APPLICATION NUMBER: 23/00853/ANM

DELEGATED DECISION CHECKLIST AND REPORT

Address: Hexpol Tpe Ltd Don Street Middleton Rochdale M24 2GG

Proposal: Application for non-material amendment to planning permission 21/00744/FUL for the proposed handing of 'cherry' house type on plot 143 and change to layout at rear of plot 262.

Proposed amended layout – plot 143 mirrored

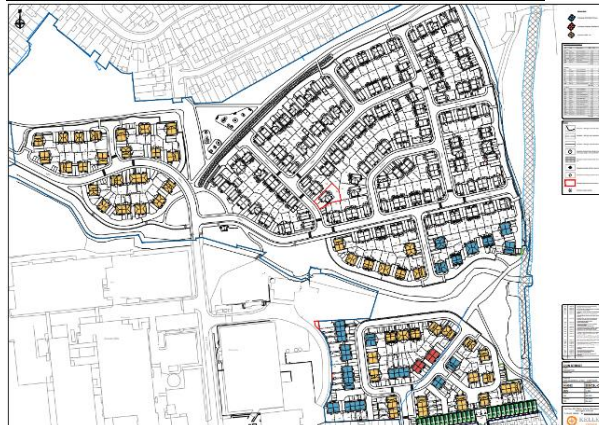
The mirroring of the unit at plot 143 is not considered to be a material amendment, in terms of all relevant planning considerations, relative to the scale and nature of the approved scheme.

The 'Cherry' housetype is a two-storey house with a two-storey side gable, and plot 143 is set between other houses on the street. Mirroring the unit will not have a material impact on any of the adjacent units in amenity terms. It is noted that the housetype at the closest adjacent plot, 144, has small windows at ground and first floor facing plot 143 at close proximity. One of these serves a WC and the other is a secondary window serving an open-plan kitchen diner. Therefore it is considered that the closer placement of the deeper main body of the house at 143 would not result in any greater impacts in terms of outlook or daylight. The alteration would not result in any greater impact on amenity to the occupants of the houses at the other adjacent plots 141 and 142.

The amendment at plot 143 would not give rise to any material change to the character or appearance of the approved development and is therefore considered to be non-material in design terms.

Proposed Amended Site Layout – Plot 262

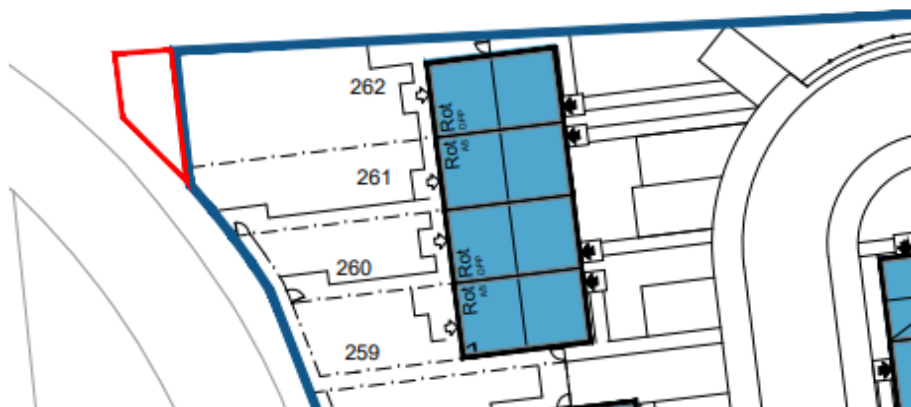
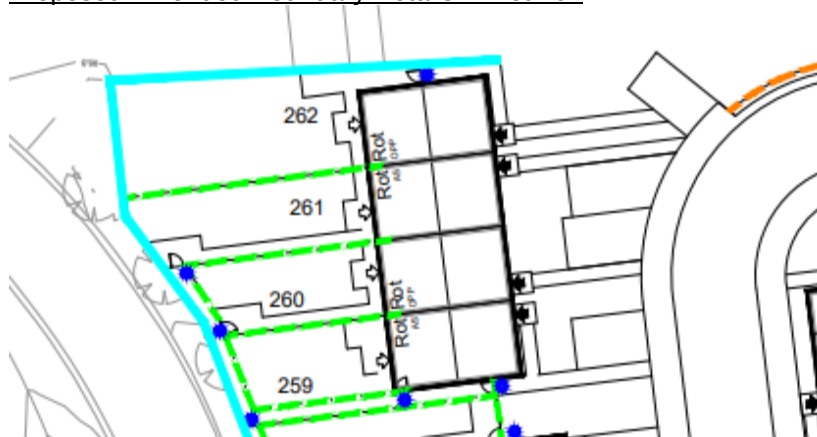
The application originally proposed to alter the red-line application site boundary to reduce the land included at the rear of plot 262, as shown below.

However, it was considered that an alteration to the application site boundary cannot appropriately be achieved through this S96A application, and procedurally speaking is not necessary in order to reduce the extent of the garden, as these changes can be undertaken within the site boundary originally approved.

Following discussion with the developer it was agreed that the scope of the application would be modified to allow for approval of the reduction in the depth of the garden (from around 20m approved to around 16m) and to the boundary treatment, without the application site boundary being modified. The description of development for the application has been modified accordingly to refer to the change to the layout at plot 262 rather than a modification to the site boundary.

The reduction in the extent of rear garden and the corresponding alteration to the boundary treatment at plot 262 would not materially change the approved development in any relevant regard, including in terms of design or the standard of accommodation for future occupiers. This alteration is likewise therefore considered to be non-material in nature.
